Addendum 02

MRPL Tender No. 3200000481 dated 16.01.2021

TENDER FOR LSTK PACKAGE FOR PFCC UNIT FLUE GAS WET GAS SCRUBBER SYSTEM AT MRPL, MANGALURU

Addendum 02 – Annexure -1: Commercial Addendum

Area Classification Layout of PFCC Unit

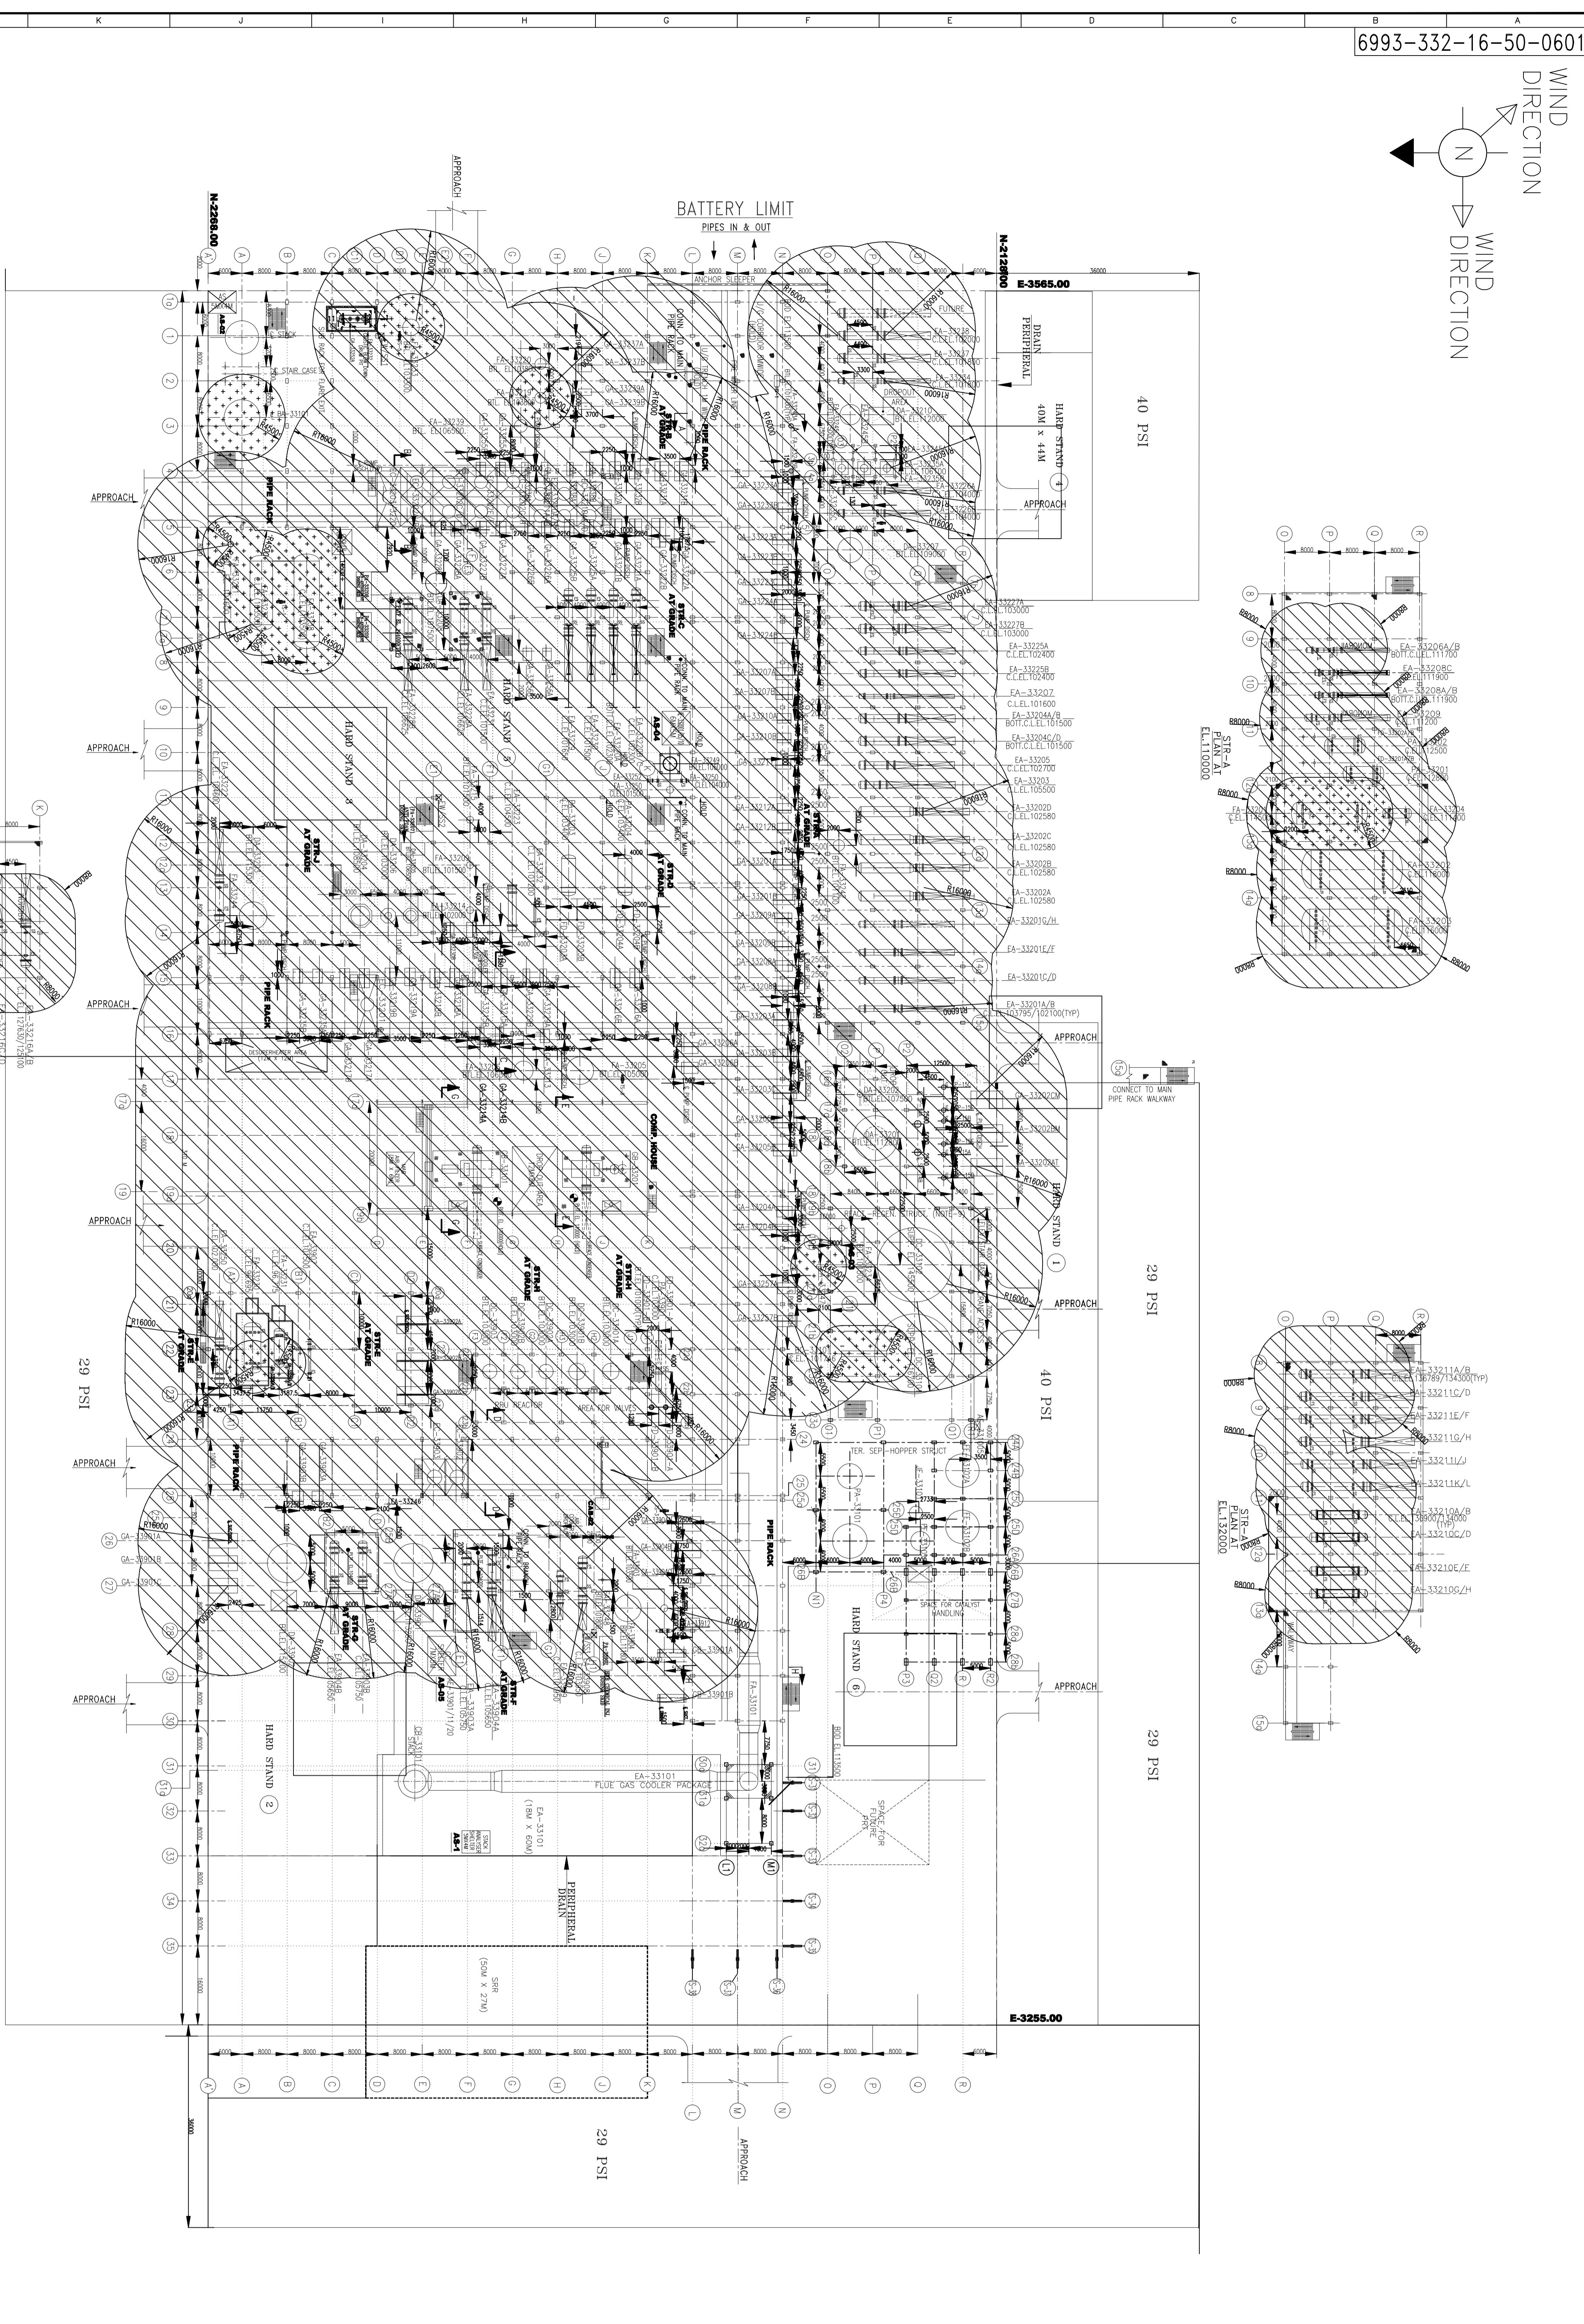
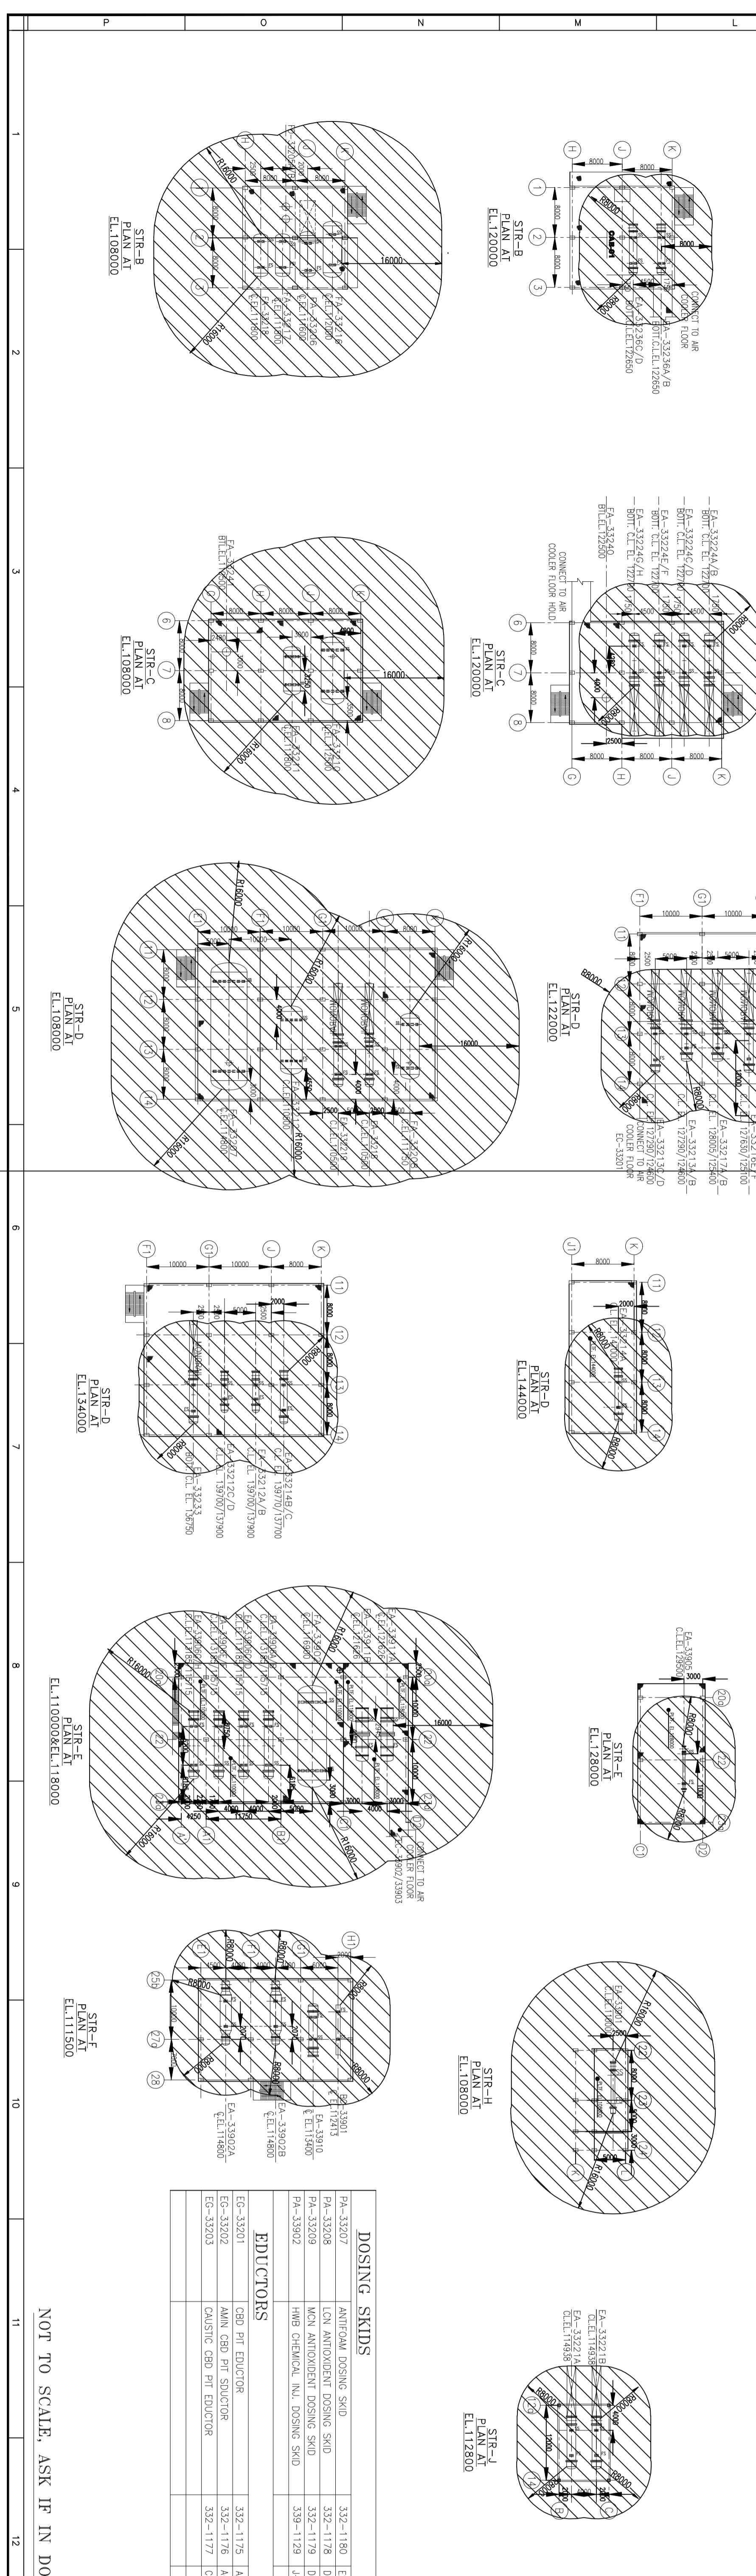
SL. NO.	BIDDING DOCUMENT		SUBJECT	BIDDER'S QUERY	OWNER'S REPLY
	PAGE NO.	CLAUSE NO.			
1	25 of 27	VOLUME_2_2 6723-ELT-331-CA-0001_000_00_Electrical LOCAL CONTROL STATION PART-II DESIGN DATA SHEET	Hazardous Area Classification	As per tender Doc- Local Control Station Data sheet mentions "Hazardous area classification: NOT APPLICABLE" whereas, - LOW VOLTAGE INDUCTION MOTORS Data Sheet (6723-ELT-331-EC-0007) mentions "Hazardous Area Enclosure Protection: To be selected as per hazardous area classification drawing" - Electrical Design Basis doc. no. EDB003, clause 4.2.1 mentions "area shall be classified as applicable". Bidder requests client to confirm the hazardous area applicability; and provide Hazardous Area Classification Drawing, if applicable.	There are no hazardous chemicals in WSS plot. However, WSS plot is a part of PFCC Unit. The effect of hazards in PFCC Unit on WSS area is to be checked by LSTK contractor and to be considered for selection of equipment of WSS unit accordingly. The area classification layout of PFCC Unit (Doc No. 6993-331-16-50-0601 Rev C) is attached herewith as Attachment-5.
